JNU EGAN DRIVE GUARDRAIL REPLACEMENT

PROJECT NO. NH-0932(049)/Z681290000

Project As-Built Drawings have been reviewed by the Project Engineer and represent to the best of my knowledge the project as constructed.
 PE: *Randall E. Johnston* Date 07.05.2019

PLAN
NORTH END
(SITE 3N)

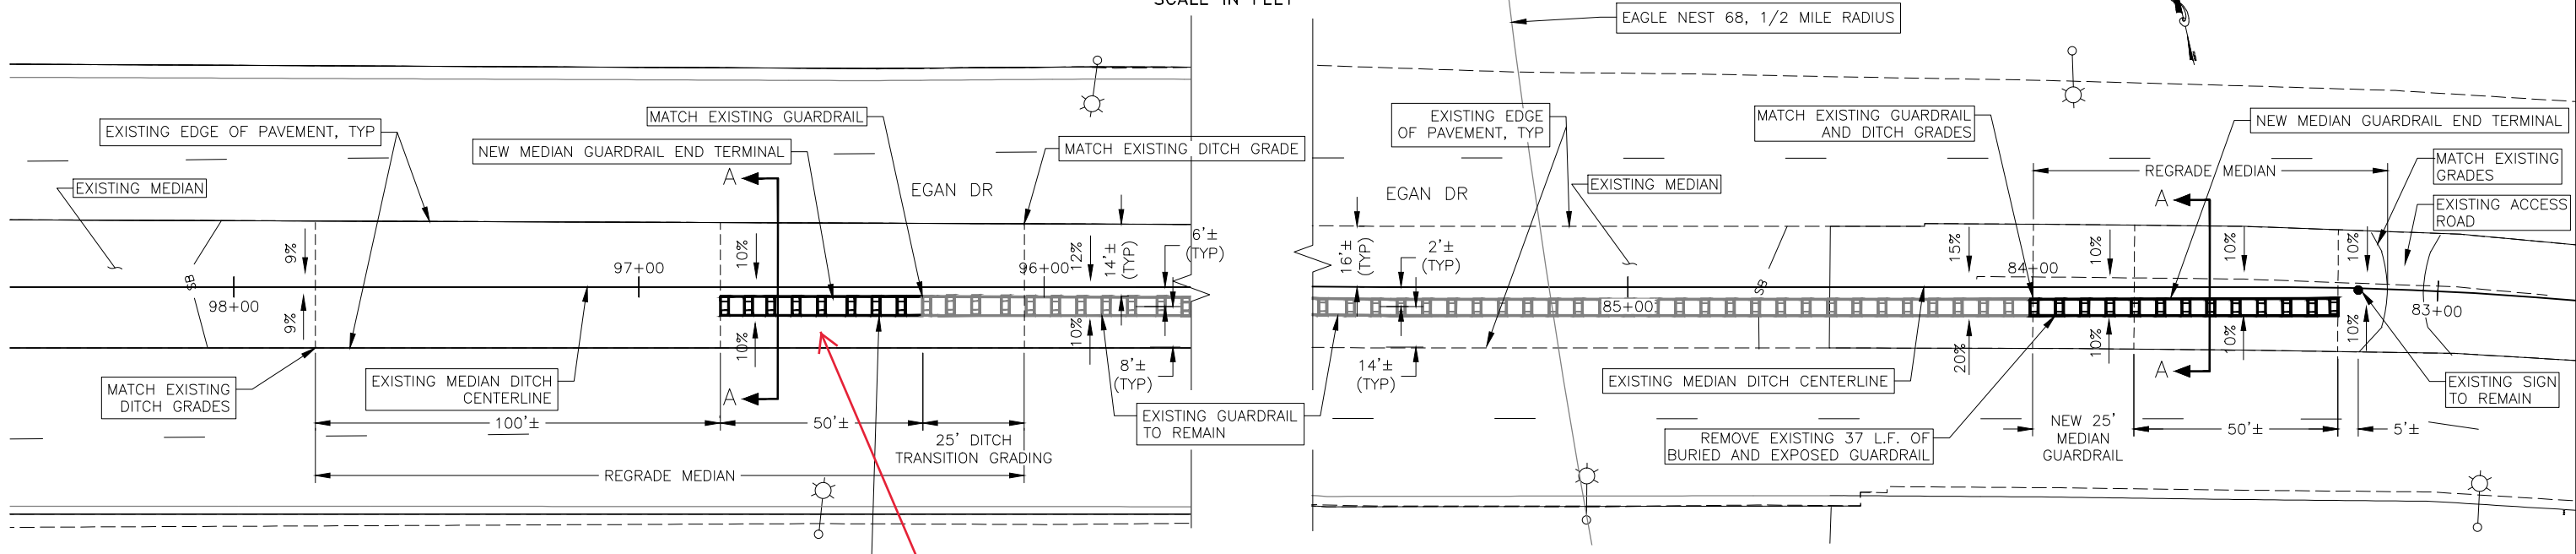
REMOVE EXISTING 30 L.F.
OF BURIED GUARDRAIL.
PLACE NEW END SECTION

+12.50' 606(8) Double faced

SITE 6

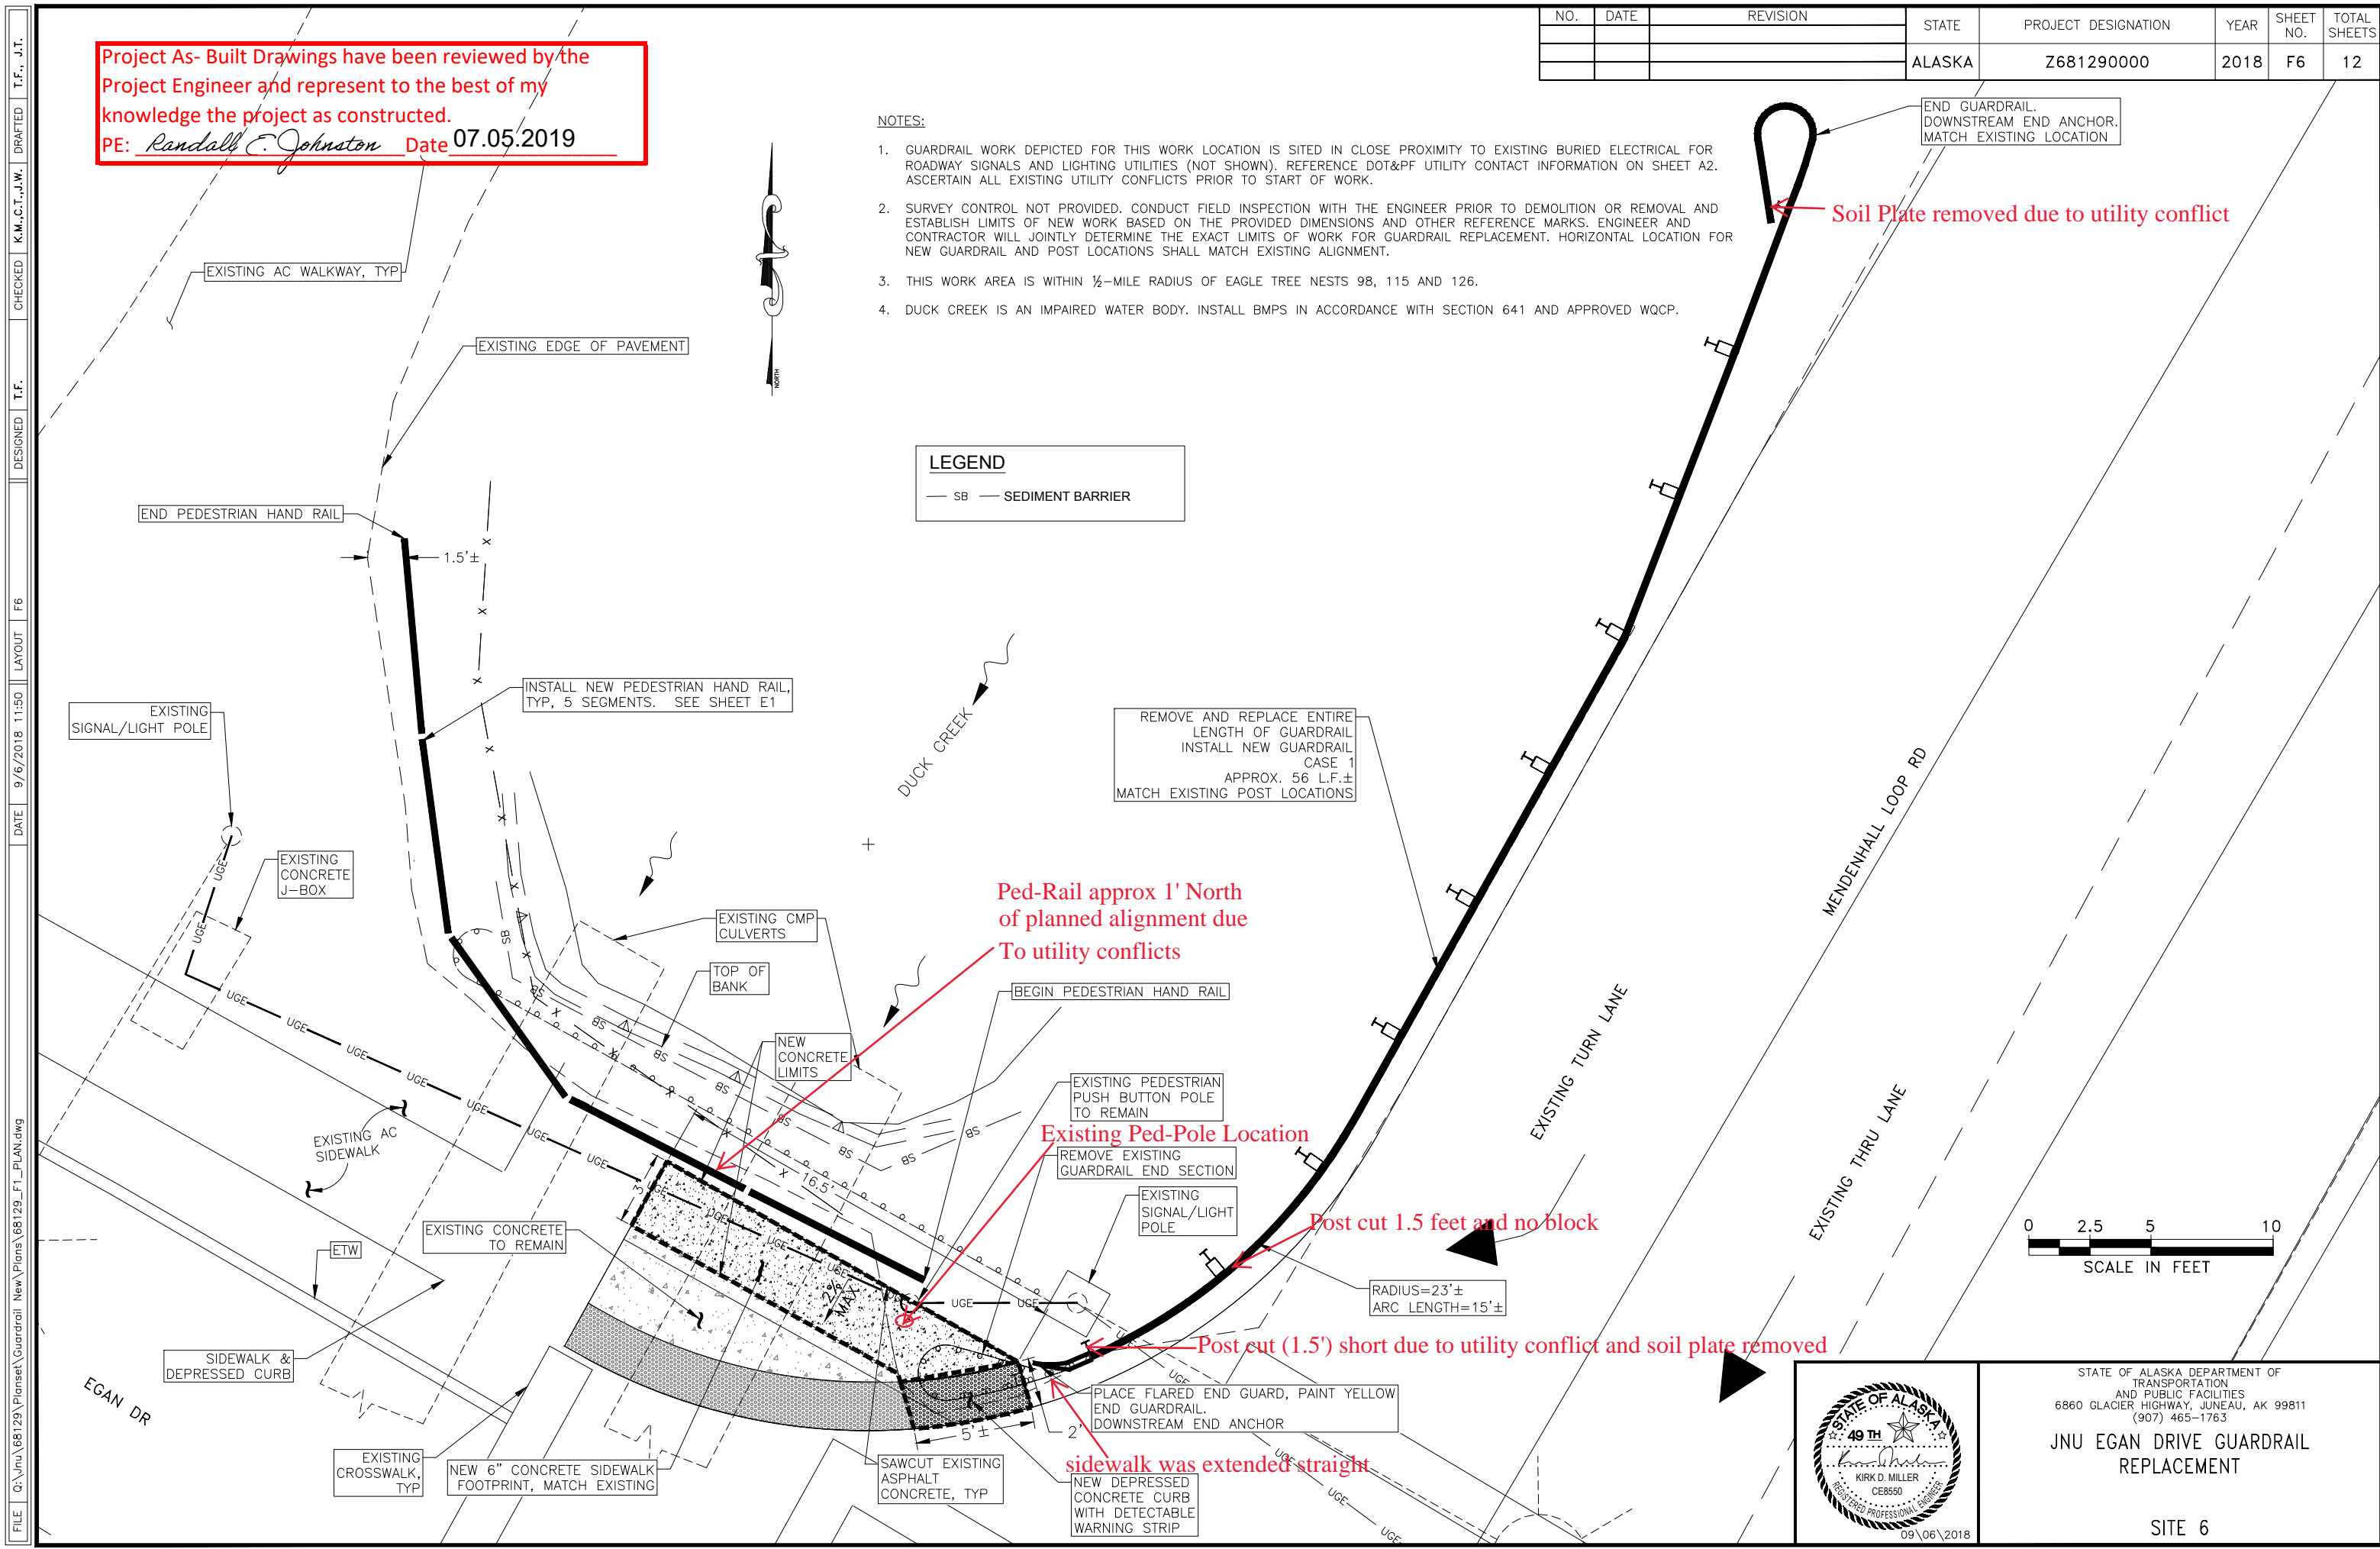
Soil Plate removed due to utility conflict

Ped-Rail approx 1' North of planned alignment due to utility conflicts

Post cut 1.5 feet and no block

Post cut (1.5') short due to utility conflict and soil plate removed

sidewalk was extended straight

SITE 7

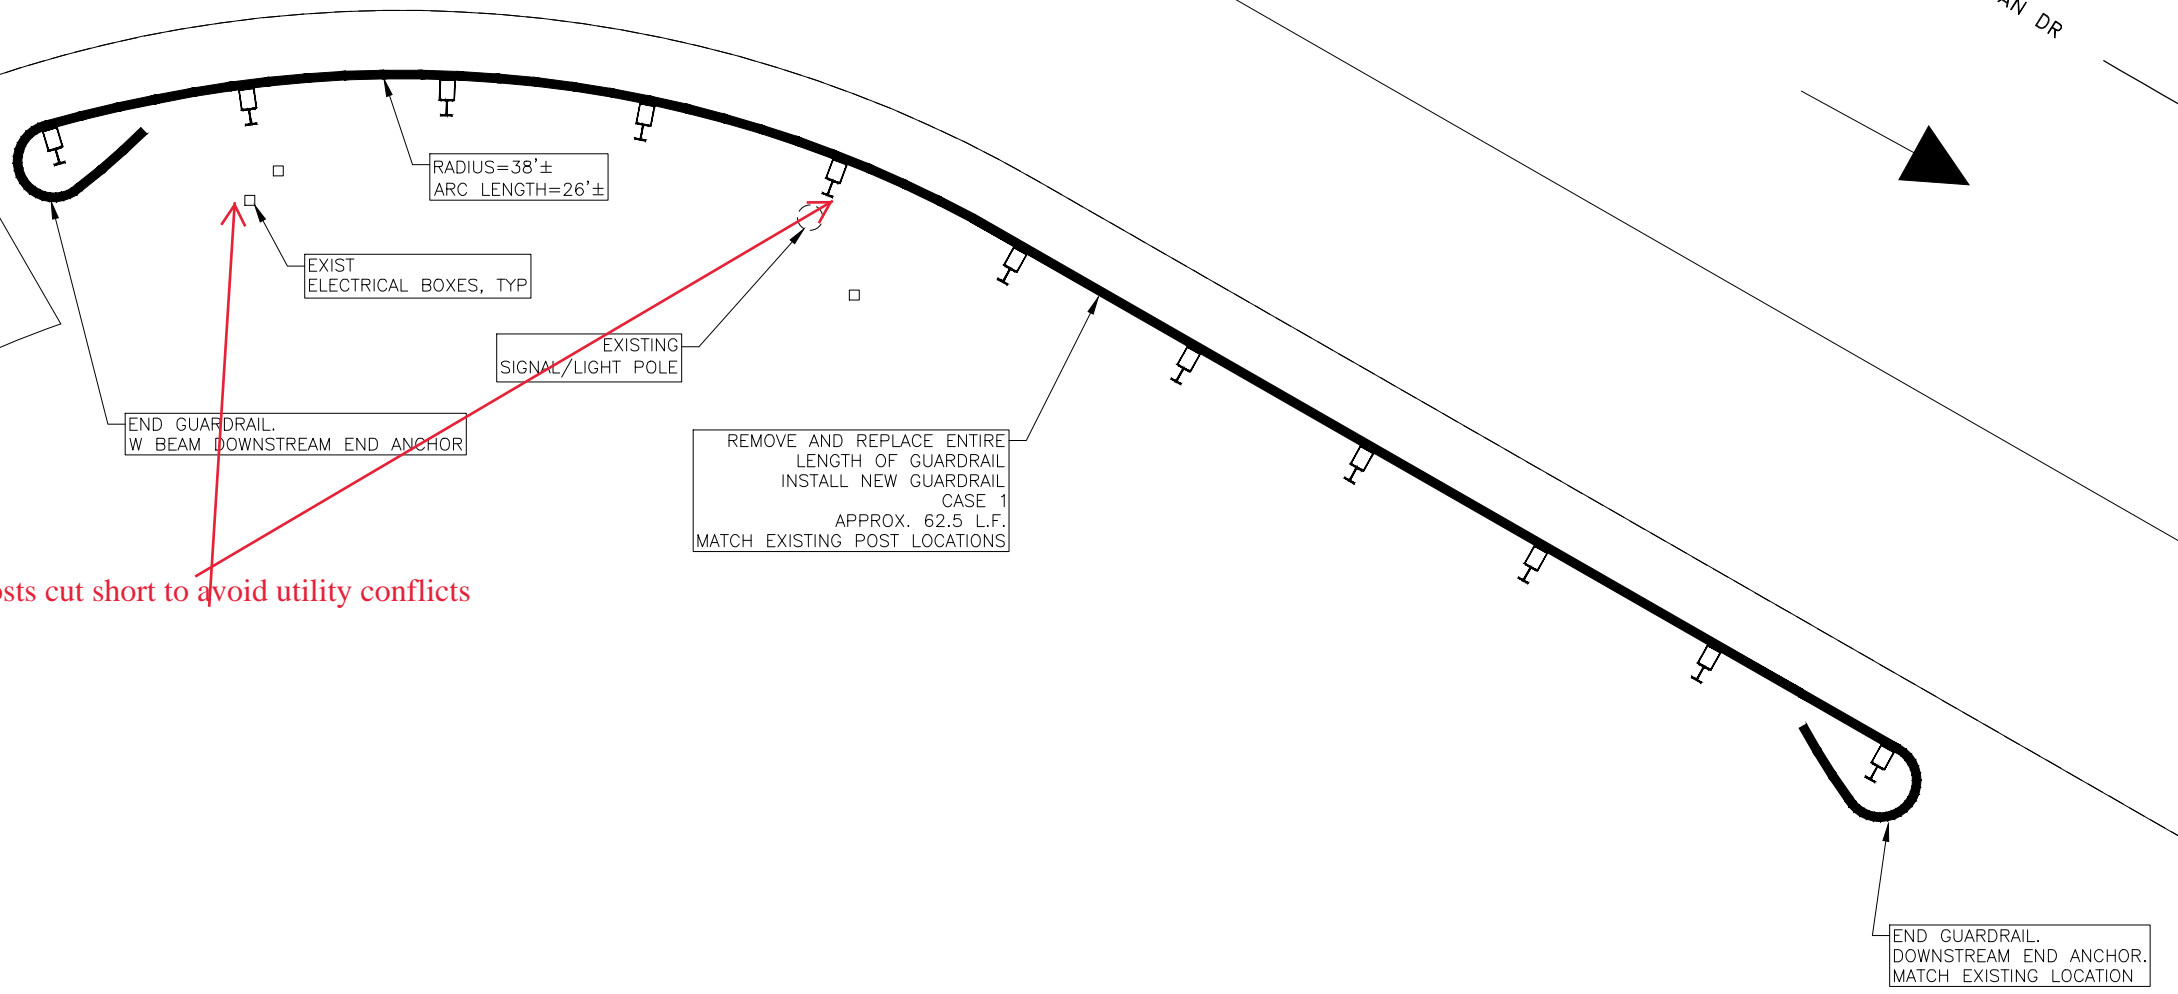
Radius realigned slightly to avoid utilities

Posts cut short to avoid utility conflicts
